NSD-NRC-96-4854
DCP/NRC0632

SUBJECT: Responses to NRC Questions Related to Building Seismic Design

DSER Item 3.7.2.8-3 (OITS #660)

DSEI Open Item 3.7.2.8-5 (OITS #662) Turbine Building Seismic Design

Figure 1 - Impact Velocities Associated With Radwaste and Auxiliary Buildings

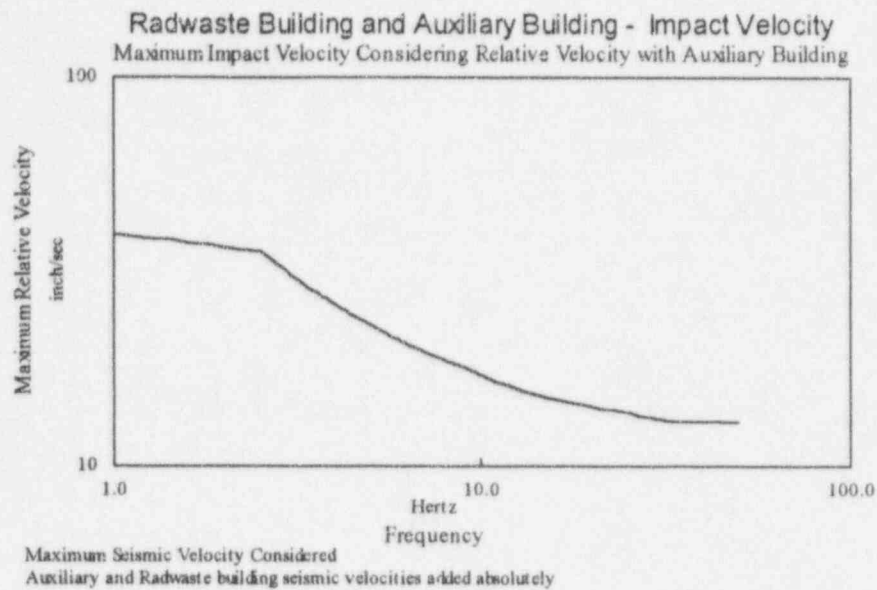
If the Radwaste Building was to impact on the nuclear island or collapse during an SSE, it would not impair the integrity of the concrete nuclear island. Westinghouse's justification is based on judgement and does not provide an adequate basis to the staff. Please provide adequate basis.

Figure 1 provide a plot of impact velocity versus the range of potential Radwaste building frequencies. It is not expected that the building frequency will be as high as 33 hertz; however, the frequency range is extended to this level for completeness. The impact velocity is the absolute sum of the Radwaste Building velocity and the Auxiliary Building velocity.

The kinetic energy of the of the Radwaste Building impact is defined at impact in the most conservative manner using the velocity (Figure 1). The velocity is defined as the absolute sum of the Radwaste and Auxiliary seismic velocities.
